Access Compliance Report

Public Rights-of-Way

(Curb Ramps)

Intersection ID: N/A	Main Street: MEADOW_VISTA_RD	Cross Street: OLD_CONCORD_RD	Location: NW
ADA ID: EF83861876E3	Ramp Type: PerpDiag	Initial Pass/Fail: Fail	Overall Compliance: No
		Severity Score: 10

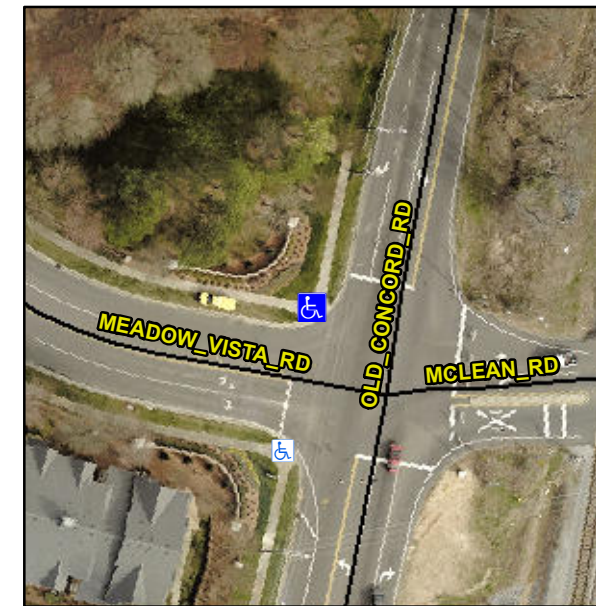
R304.5.1, R304.5.3

Compliance	Description	Data	Compliance	Description	Data
N/A	Ramp Length (in)	42.0	Yes	Ramp Slope (%)	5.2
No	Ramp Width (in)	41.0	No	Ramp XSlope (%)	2.5
N/A	Flare Type LT	N/A	N/A	Flare Type RT	N/A
N/A	Flare Slope LT (%)	N/A	N/A	Flare Slope RT (%)	N/A
N/A	Flare Traversable LT?	N/A	N/A	Flare Traversable RT?	N/A
N/A	Landing Length (in)	N/A	N/A	DWS Provided?	N/A
N/A	Landing Width (in)	N/A	N/A	DWS Contrast?	N/A
N/A	Landing Slope (%)	N/A	N/A	DWS Length (in)	N/A
N/A	Landing X Slope (%)	N/A	N/A	DWS Full Width?	N/A
N/A	Landing Curb? (Y/N)	N/A	N/A	DWS Offset (in)	N/A
N/A	Shared Landing?	N/A			
N/A	Gutter Ponding?	N/A	N/A	Gutter Slope (%)	N/A
N/A	Gutter Lip Ht (in)	N/A	N/A	Gutter X Slope (%)	N/A
N/A	Painted X Walk1?	No	N/A	Painted X Walk2?	No
	X Walk 1 Direction	To S		X Walk 2 Direction	To E
N/A	X Walk 1 Width (in)	N/A	N/A	X Walk 2 Width (in)	N/A
	X Walk 1 Slope (%)	0.8		X Walk 2 Slope (%)	3.2
	X Walk 1 X Slope (%)	0.1		X Walk 2 X Slope (%)	1.5

Remove & Replace Curb Ramp With Two New Directional Ramps or Equivalent.
